RE: NCWT concerns

Subject: NCWT concerns

I walked the NCWT in Balcones during the rain last Friday and noticed some issues:

Sheet 47 noting erosion control blanket placement:

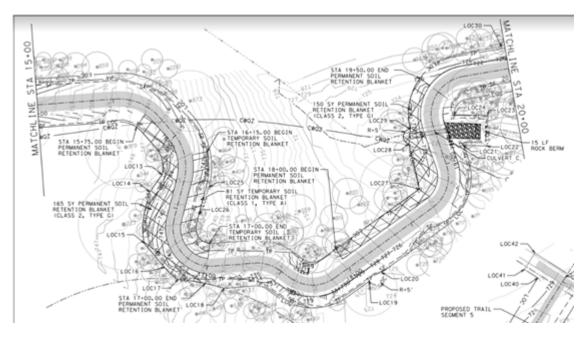
Larry, regarding tree replacement on Segments 1-2, when will this occur? Also, when will the broken irrigation pipe be removed?

Unfortunately my phone started getting wet and shut down, so I did not get any of the water jumping the gutter on Scribe. I took pictures of some of the areas where the road base was left a steep angles to illustrate another problem - stabilization of the side slopes. I believe the plans call for vegetation with erosion control blanket in specified areas (ref plan sheets 46-48, 51-54). Toeing in the blanket will be a problem here. Getting topsoil to adhere to the roadbase will be problematic and vegetated growth will be retarded by the lack of organic material and poor root penetration. Leaving the roadbase side slopes unvegetated is not acceptable as over time the fines will wash out of the base, releasing large aggregate.

After the first onsite meeting to identify the tree replacement, the sub-contractor has become non-responsive. The City along with the Prime Contractor are working to resolve this situation.

Segment 1-2 (that was never properly restored)

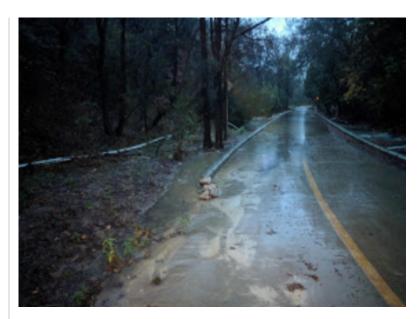
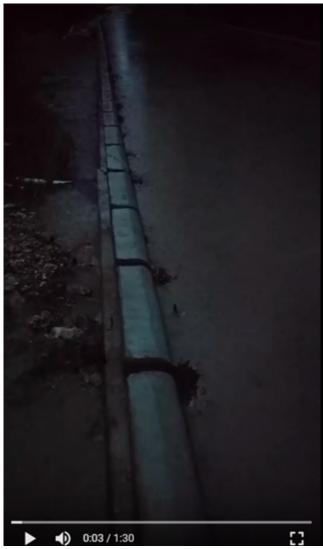
- water was ponding on the bridge deck due to clogging of the drainage slots - these need to be saw cut wider to prevent clogging. The left hand side of the trail approaching the culvert should be reshaped to allow drainage to get to the creek. Volunteers removed all the accumulatted soil from the deck on Nov. 3rd, but it has returned due to soil washing from the unrestored trail side area.

observe that no water is flowing through the cuts, once I cleared a couple of these leaf jams, the deck started draining.
